RDG BLOCK 3A

Recommendation Meeting

SDCI Number: 3024695

Monday 30th October, 2017

1 Setback Section at North East Facade

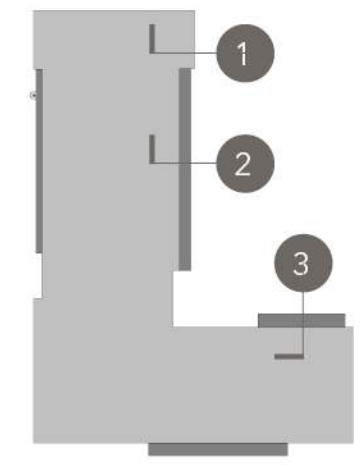
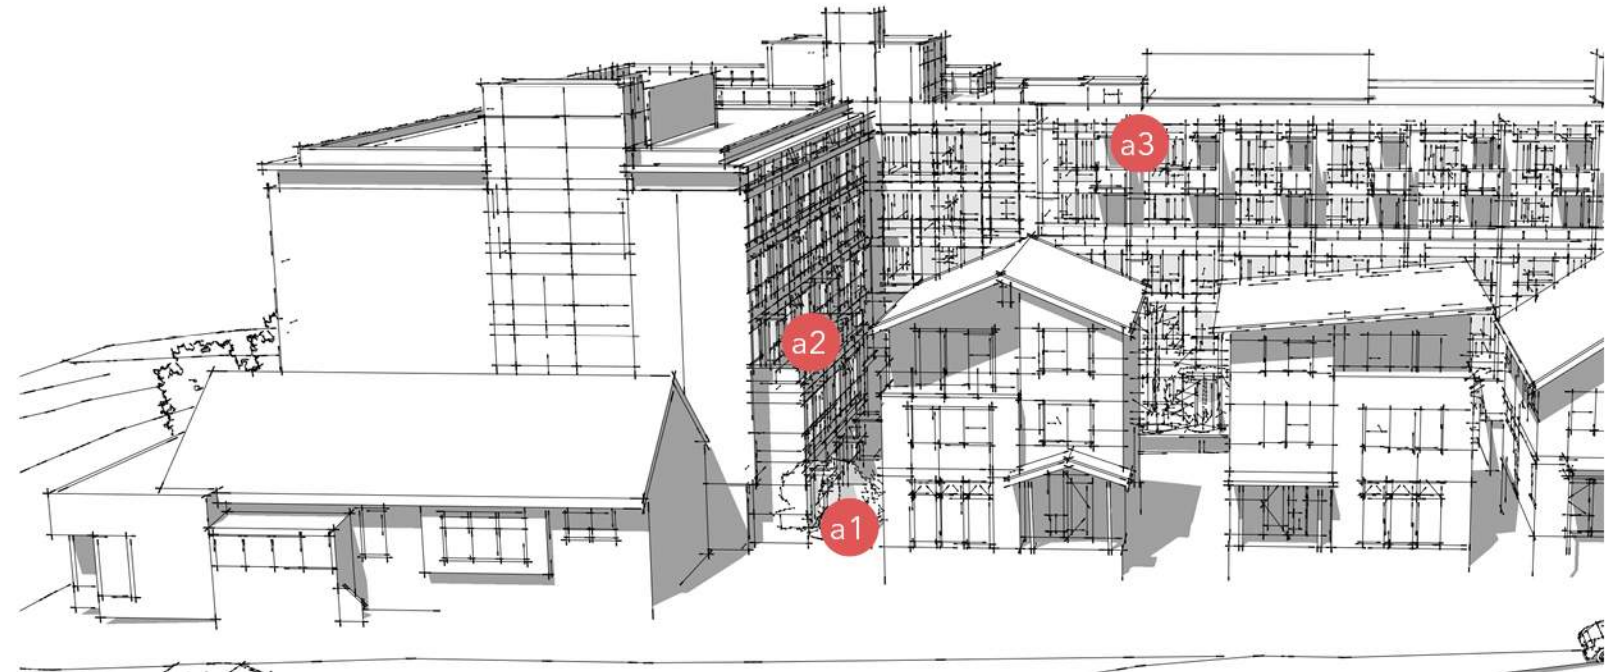
- a. The Board discussed the requested departure for reducing the required 15' setback adjacent to the single family zone to 10', and did not think the justification and massing concept provided at this time was valid. As proposed, the continuous setback all the way to the ground creates a poor transition and monolithic structure. Ultimately, the Board was not opposed to a departure from setback requirements, but not as proposed and the applicant would need to provide further study of the setbacks to demonstrate that it would result in a reduced perceived height, bulk and scale along the eastern portion of the building. (CS2-D)

- b. Echoing public comment, the Board directed the applicant to conduct additional sun/shadow studies and explore solutions to minimize the shadow, for instance, looking at a code compliant option or setting back the east edge of level 4. (CS2-D, CS1-B-2)

- a1 The project team is requesting a departure at the northeast corner of the northern wing where the proposed building abuts the east property line. For the 17'-0" setback from the property line the requirement is typically at 40'-0" high, the project is requesting the setback to continue to go up to 48'-0" high. The departure is for 31 feet in length of the facade at level 5. Level 1 is setback 16'-0" more than the code required. Level 2, 3 and 4 are setback 1'-0" more than code required. Such uniform facade creates an end frame for the northeast corner which matches the northwest corner of the building mass. No departure is needed for the mid-block of the northern wing as building steps back at level 4 and 5. See comment "b" below.

- a2 The project team is requesting a departure at the northeast corner of the south wing where the proposed building abuts the inner north property line. For the 17'-0" setback from the property line the requirement is typically at 40'-0" high, the project is requesting the setback to continue to go up to 48'-0" high. The departure is for the full length of the inner north facade. The intent is to avoid the "wedding cake effect" at level 5.

- a3 At the northeast corner of the south wing where the proposed building abuts the inner north property line, the project is requesting a departure for the 15'-0" setback requirement above the 13'-0" height to be at 19'-6' height for the facade length of 46 feet at level 2. Level 1 is setback 8'-5" more than code requirement to create a landscape buffer zone and outdoor patio spaces. Level 3 and 4 are setback 6" more than code requirement. The overall building mass is step down for a gradual transition adjacent to the single residential homes. The two story building mass helps to break up the monolithic facade while providing an outdoor area above grade.

- b1 Shadow studies included in this package shows the impact of the new future building across 15th Ave NE (RDG Block 2) would create a long shadow on the single residential family houses on 16th Ave NE. Shadows from the proposed building will not have additional impact on the single family residential homes. See page 55

- b2 Level 4 and 5 are setback 8'-6" more than code requirement at mid-block of the northern wing. The setback will reduce the perceived height, bulk and scale along the eastern facade. The upper levels setback with decks, balconies and railings are added to provide privacy separation from the single family residential homes. Level 1 is setback 16'-0" more than code requirement to create a buffer zone with landscape and outdoor patio spaces.

View looking West of residential houses and proposed building behind

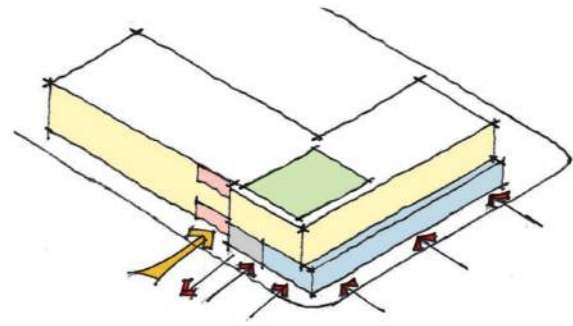
- a. The Board agreed with public comment and directed the applicant to explore measures to soften the zone transition and reduce the perceived height, bulk and scale of the building, including playing with the setbacks; increasing the proposed level four 2' setback to give the appearance of a 3-story façade and penthouse; or, reducing proposed lower level setbacks while increasing upper level setbacks. (CS2-D, DC2-A-2)

- b. The Board identified respect for adjacent sites as a high priority and directed the applicant to better respond to the zone transition and increase privacy by incorporating secondary architectural features such as sun shades, frosted spandrel glass, Juliet balconies or full balconies. (CS2-D, DC2-A-2, DC2-B-1, DC2-C)

- a1 At the ground level, the base of the building is setback more than code requirement to create a landscape buffer along the property edges. Trees and hedges are added to provide noise and privacy screening. Amenity courtyards and private patios are created for outdoor activities.

- a2 At mid-levels of the building, majority of the facade is setback per code requirement (see pages 12 and 13) to create a separation between single family residential homes. Portion of the building are to have outdoor decks with railings and privacy screens. These elements also helps to create modulation along the facade.

- a3 At the upper levels, area are setback more than code requirments to give the propose building facade appearance of a 4-story building. The upper level is design with a clerestory setback from the building frame to look like an attic story. On the east and west facade the upper levels is to have decks and balconies with railings and privacy screens.

- b1 Secondary architectural features includes decks, balconies, screens, canopies, to modulate the facade and add privacy for the residents
 - b2 Overall the perceived height, bulk and scale of the building has been reduced to create a softer transition between the single family residential zone.

EDG Option 3: Preferred

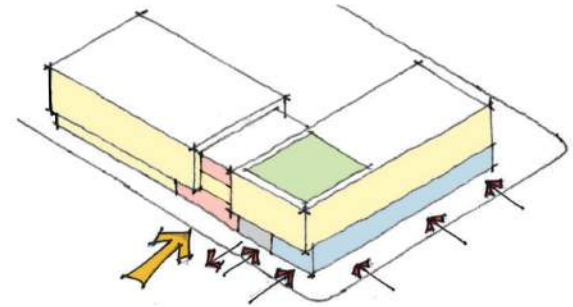
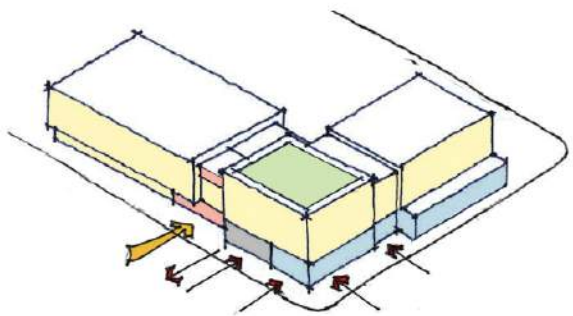
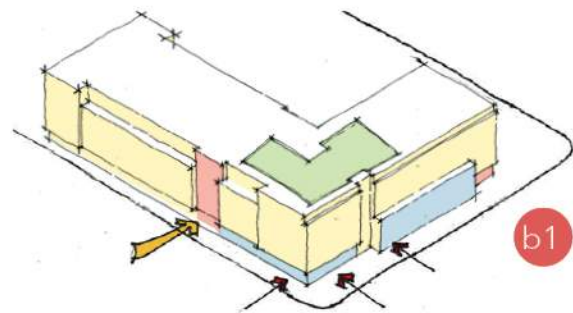
- b. The Board generally supported the proposed continuous setbacks along NE 65th St in Option 2, however, they indicated support for a hybrid alternative that minimizes the modulation of the ground level setbacks in Option 3. Specifically, the difference in setback where the ground level steps forward to meet the setback of the existing retail to the east should be reduced. (CS2-B-2, PL1-B-1, PL3-C)

- b1 The current proposal is a hybrid alternative between the EDG options 2 and 3. A generous setback is given along NE 65th St to provide outdoor plaza at the corner, with a wider sidewalk and carefully placed street trees fronting the retail space. The mid-block retail is pulled forward to create modulation along the facade and match the existing adjacent retail building. The retail bay is a strong architectural feature that allows for a change in the architectural material from the typical storefront and it allows for wider sidewalk relief on each side. With pulling the retail forward, it allows the units above to have a protected deck area on a busy street. In addition, the alcove between this bay and the existing retail creates a natural open area for the secondary residential/move-in entry.

Bus Stop Relocation Proposal

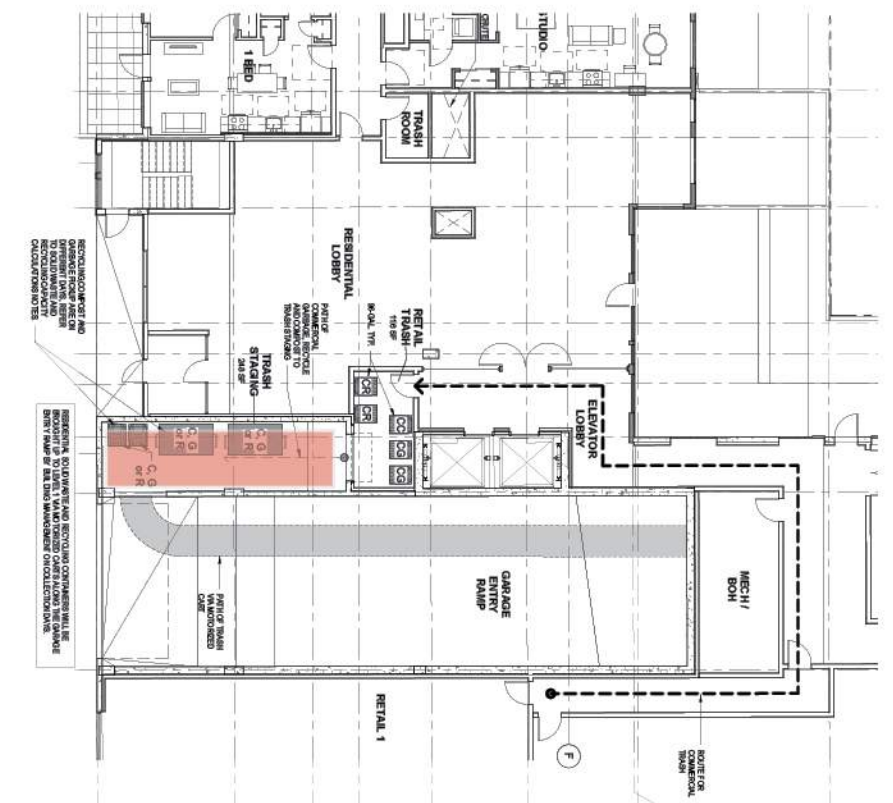
- a. The Board agreed with public comments and strongly supported relocating the bus stop to the south of the NE 65th St on 15th Ave NE, however, they acknowledged this is outside their purview. They highly encouraged the applicant to work with SDOT and Metro to explore the matter further. (PL4-C)

- a1 The owner is preparing a memo to express the current location of the bus stop creates hardship to the future building residents and the community. With the current bus stop location, the bus will be parked in front of the building entrance and will block the garage exit/entrance. At the EDG meeting, comments from the community were in favor of moving the bus stop to south of 65th St. The owner is working with Metro to determine a the best location. Bus stop relocation proposal has been created.

c1 Ground Level Residential Along 15th

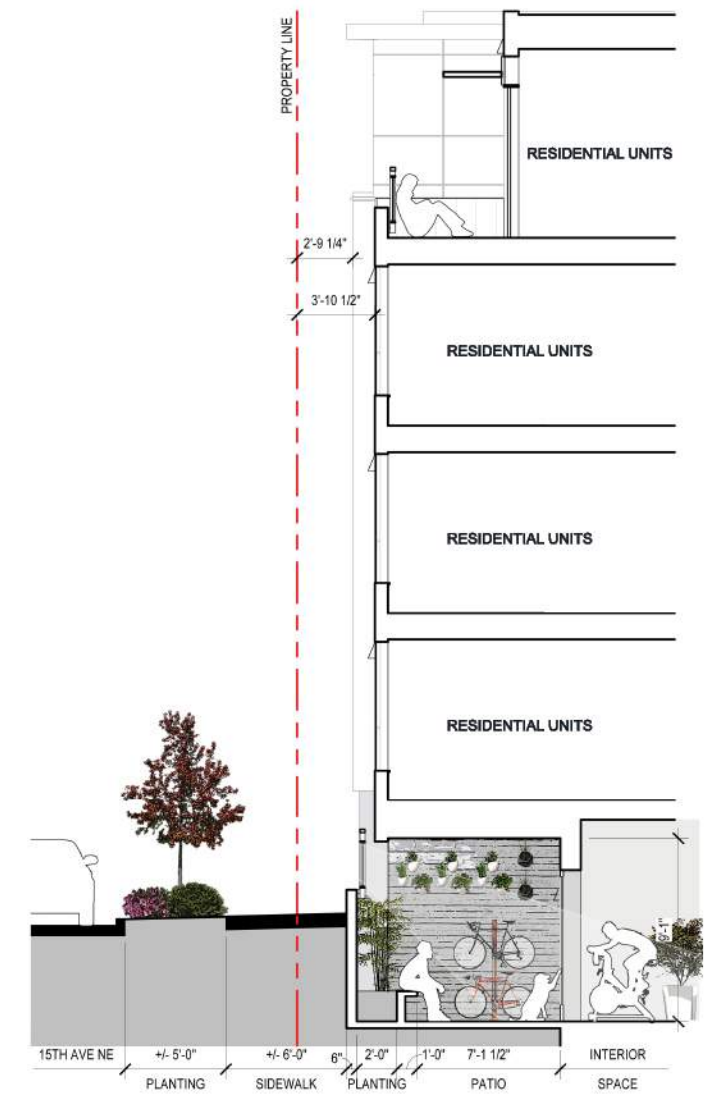
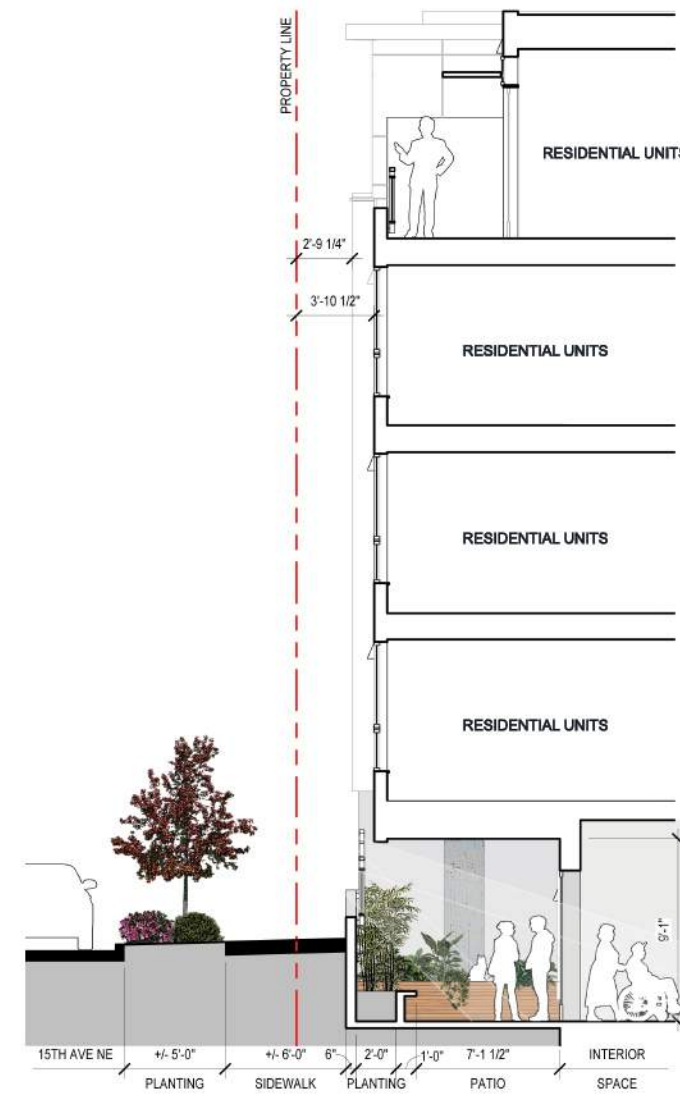
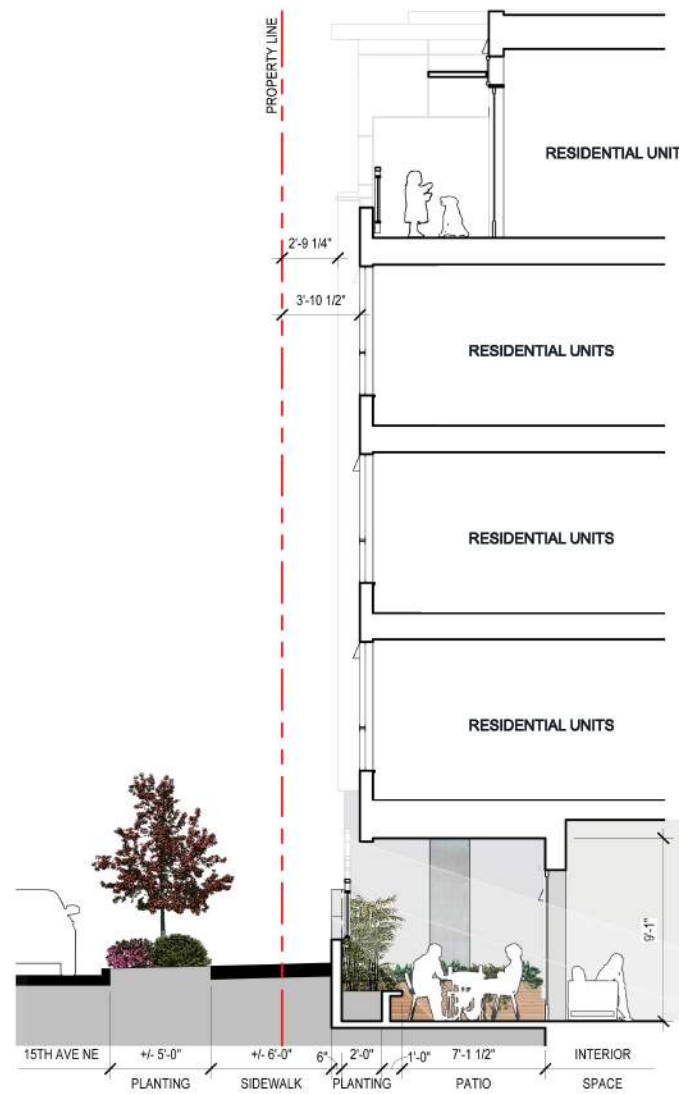
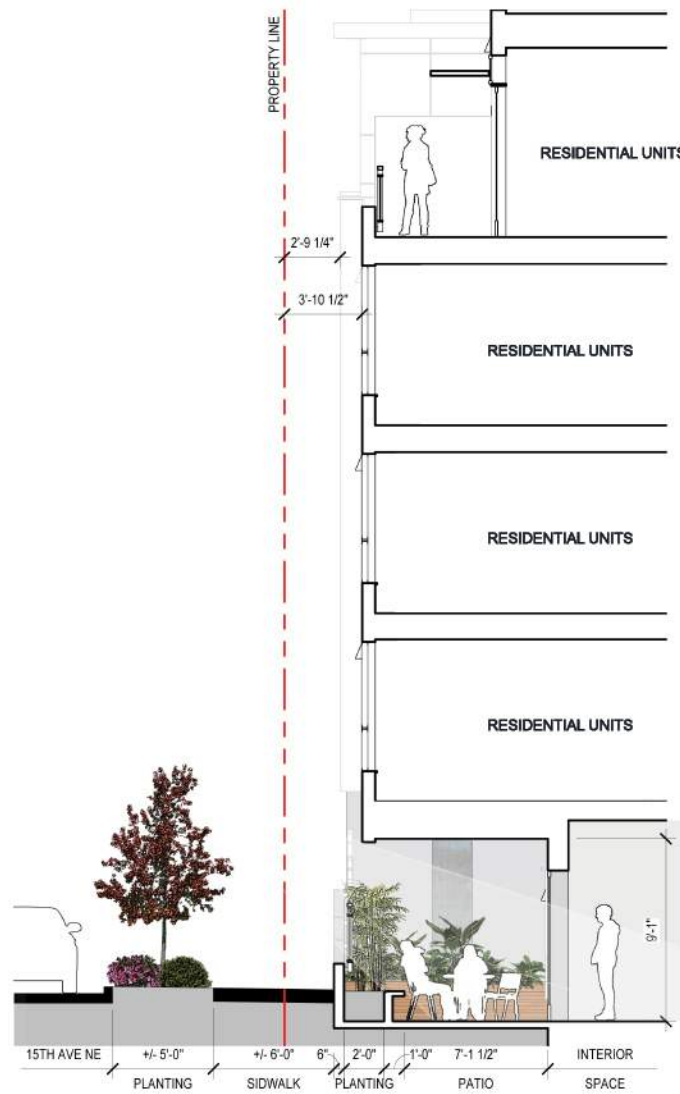
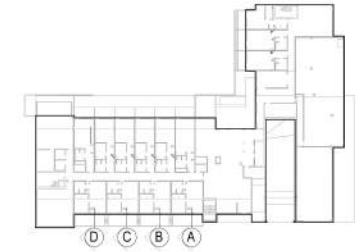
c. The Board expressed concern regarding the northwest corner and the "pinch point" created by the 5' cantilever, 10' ground-level setback and grade change along the west property line. The Board indicated they would not support the massing at this corner as shown, but would be inclined to support a departure from residential street level separation requirements in order to resolve this undesirable condition. (CS1-C, CS2-B-1, PL3-B)

c1 The overall massing along 15th Ave is redesigned to eliminate that "pinch point" at the level 2 cantilever. The departure request is also deleted from the MUP submittal. The building mass is updated to have the ground level units set back 10 feet from the back of sidewalk as allowed per zoning code. The deep setback will provide the residential units ample outdoor patio space in front of the units to serve as a buffer from the public right of way. At the back of the sidewalk landscape buffer is added in front of the guardrail for additional privacy and noise reduction, as well as soften the building edge along 15th ave.

Level 1: Trash Staging & Retail Trash Storage

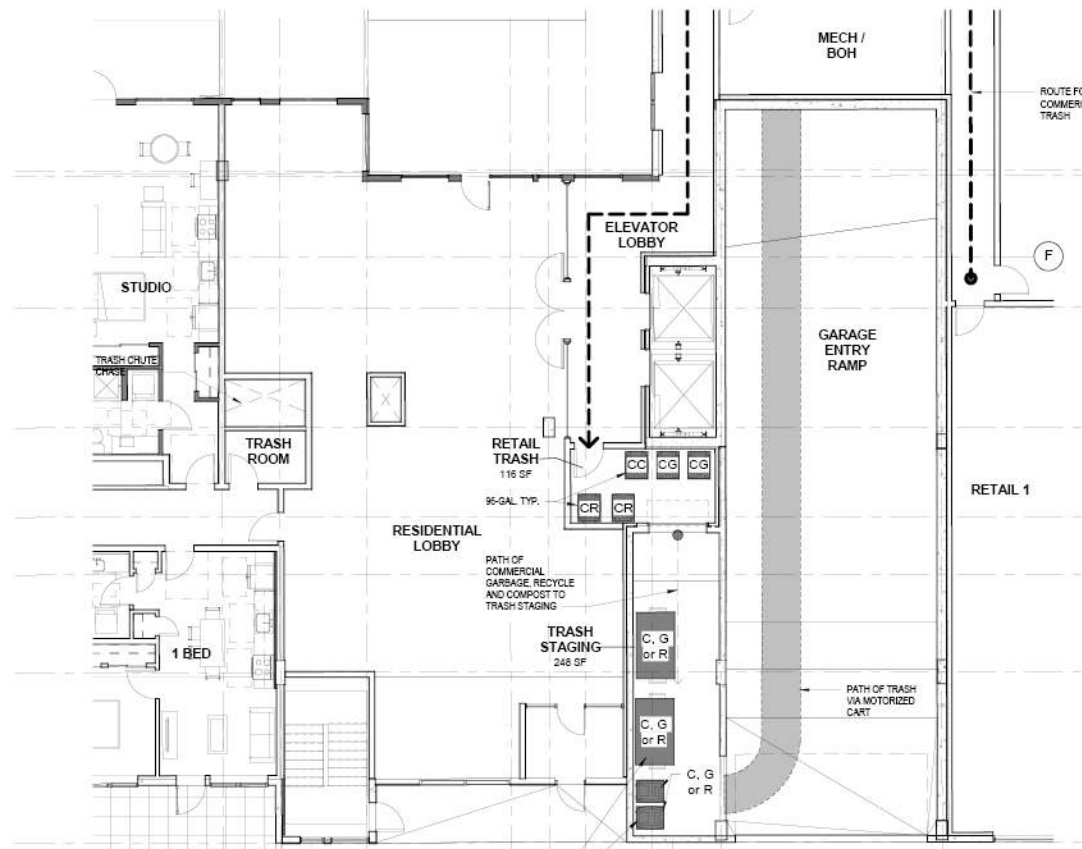
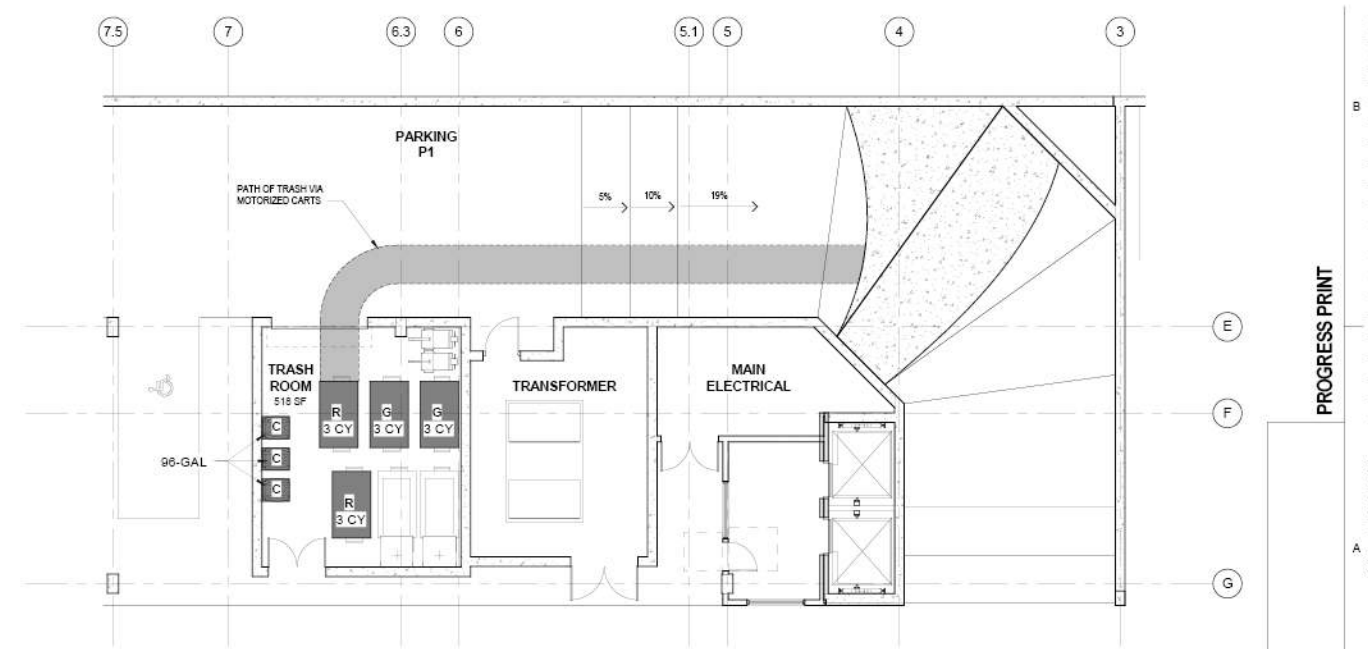
d. The Board was concerned with the proposed location of the trash room since it would require bringing the receptacles up the ramp from parking level one to the street level and staging the receptacles in the right-of-way. The Board requested the applicant explore alternative designs, or provide detailed information showing how the proposed design will successfully mitigate any negative impacts on the right-of-way and pedestrian realm. (DC1-C-4)

d1 A trash staging area is provided on the street level next to the parking garage entry. See page 53 for detail information regarding solid waste and recycling collection.
